BLM GROUP BUILDING EXPANSION JSP23-24

Public Hearing at the request of Dembs Development for approval of the Special Land Use Permit, Preliminary Site Plan, Woodland Permit, and Stormwater Management Plan. The subject property is located in Section 4, on the north side of Cartier Drive in the I-1, Light Industrial District. The subject property is approximately 7.62 acres and the applicant is proposing an proposing a 63,608 square foot addition to an existing 75,162 square foot building in the Beck North Corporate Park.

PLANNING REVIEW

PLAN REVIEW CENTER REPORT

DEMERS DEVELOPMENT, INC.
PRELIMINARY SITE PLAN
BLM GROUP USA EXPANSION - BECK NORTH CORPORATE PARK
TOWNSHIP 1 N
RANGE 6 E
SECTION 4
CITY OF NOVI, MICHIGAN

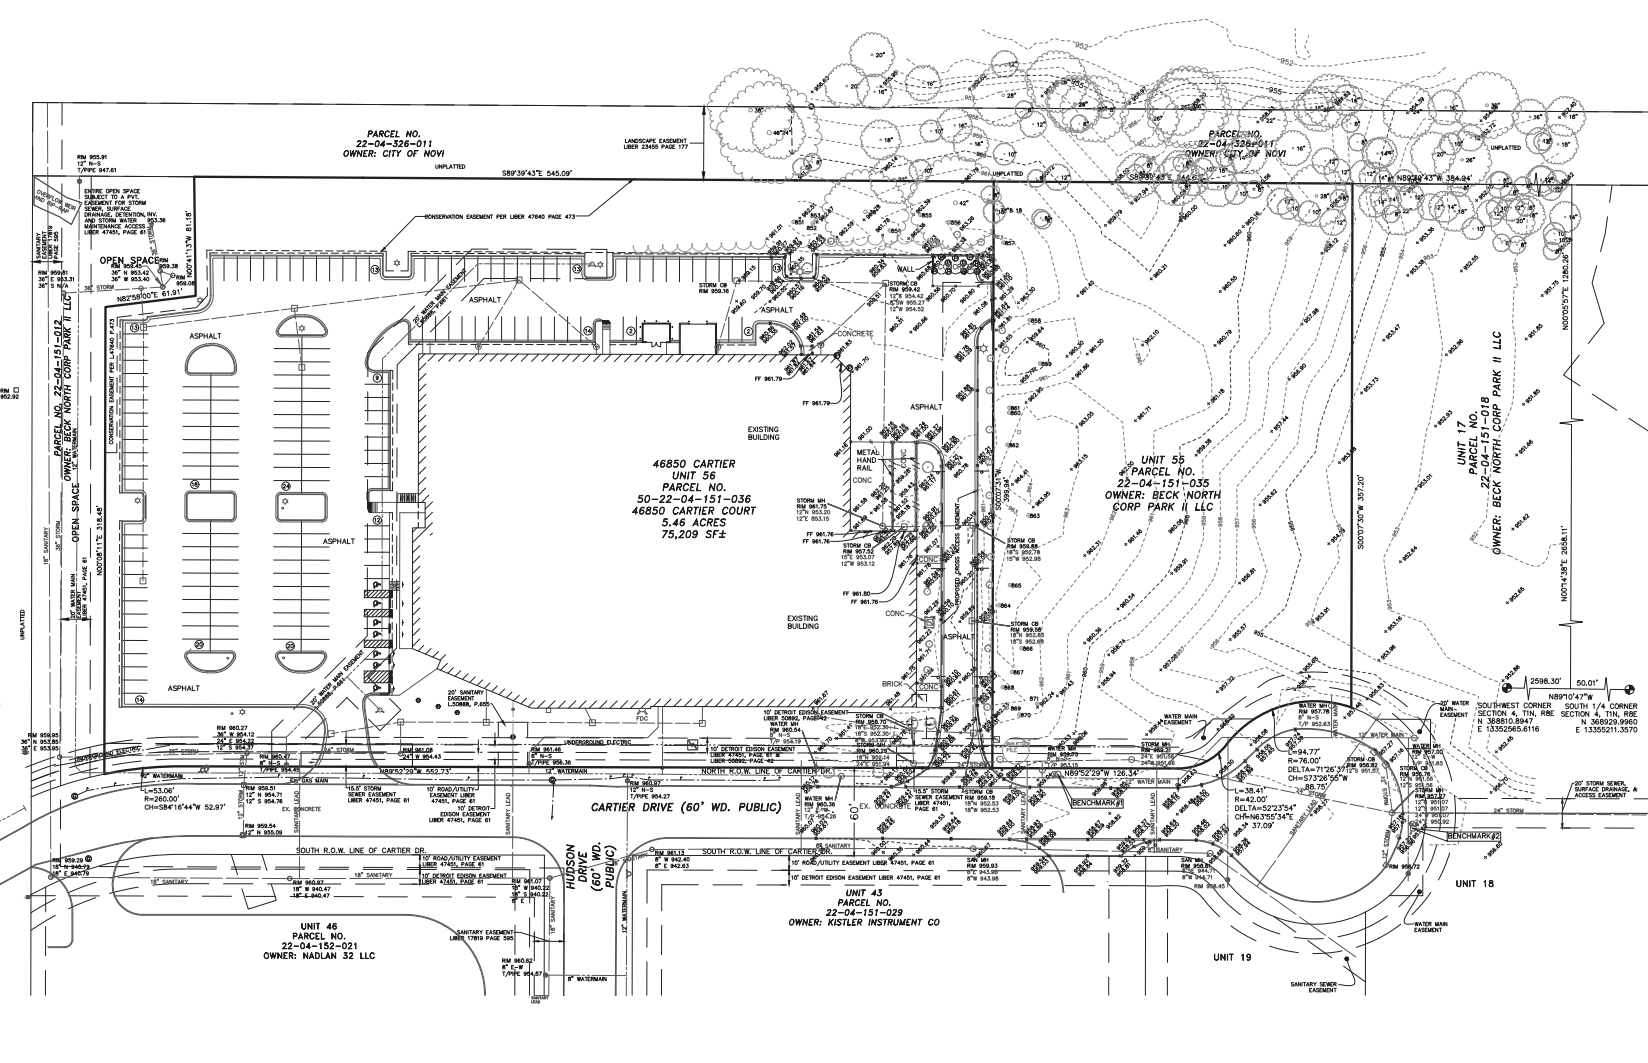
Comment: Sheet 2 – General Notes, update note 4 to reference Section 5.7 of the City Code.

Response: Note is provided on sheet 2, preliminary site plan, under general site notes (#14).

Response: Comment noted. Refer to Fire Department notes on sheet 2, preliminary site plan.

Response: Provided on sheet 2, preliminary site plan.

**Figure 1. BLM Group – existing building and location of proposed addition to the east
City of Novi Regulated Woodland Map**
*Bold red line = property boundary;
Green areas = City-regulated woodlands*

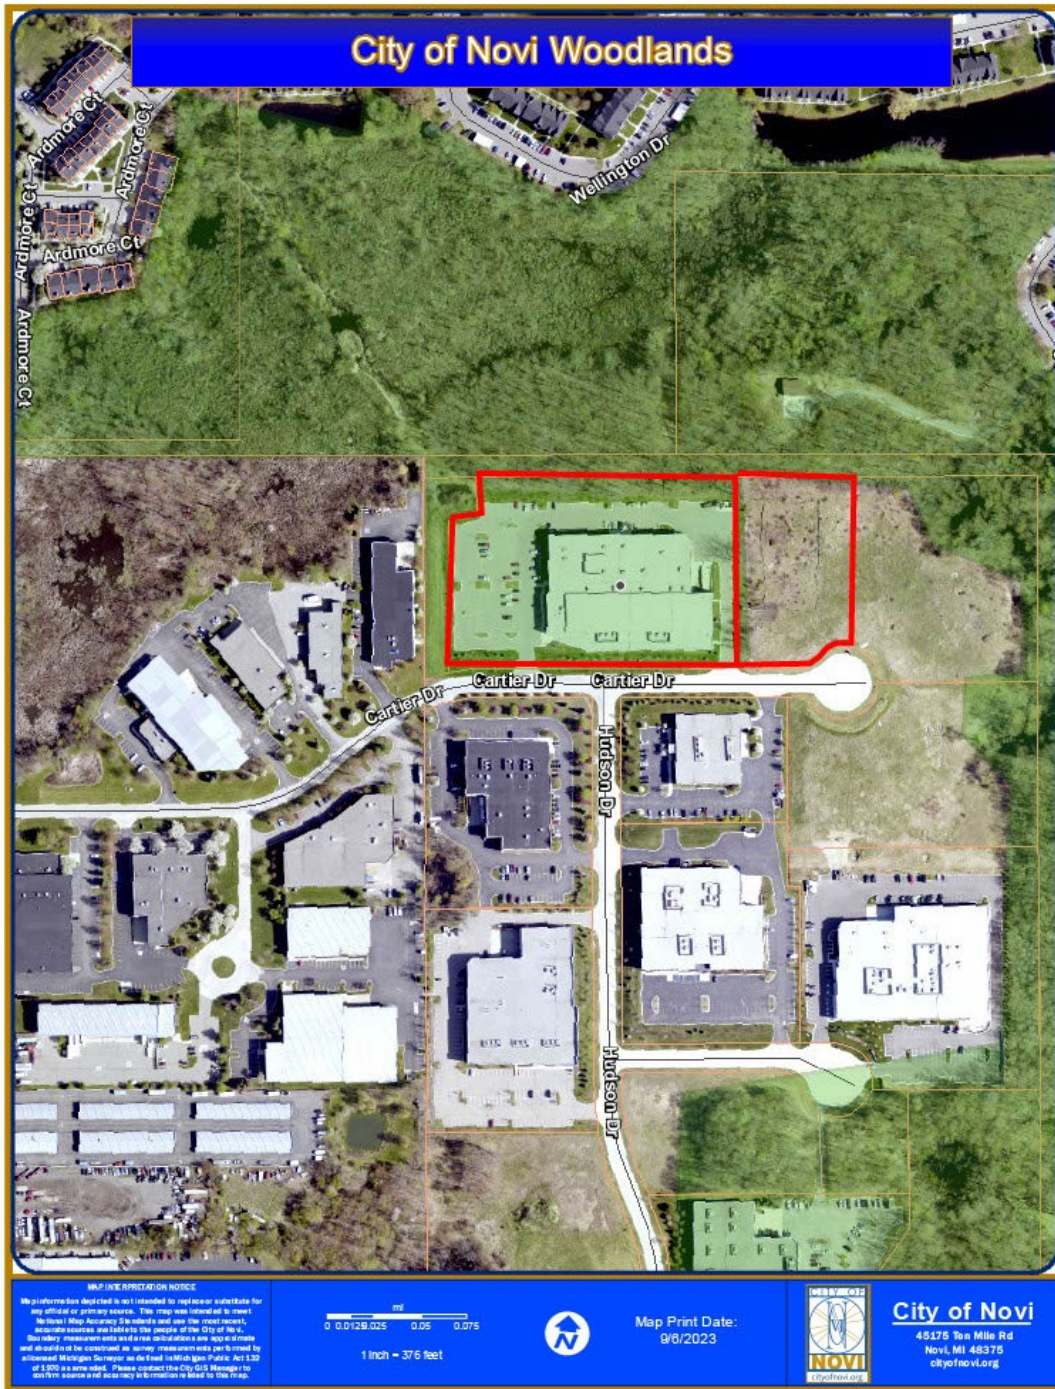
DRG conducted a site visit on September 3, 2023 (see Figure 2 site photos). There is a remaining strip of regulated woodlands between the parcel where the exiting BLM building is located and the adjacent parcel where the proposed addition will be constructed. There are also regulated woodlands along the northern property line and on the adjacent property to the north owned by the City of Novi.
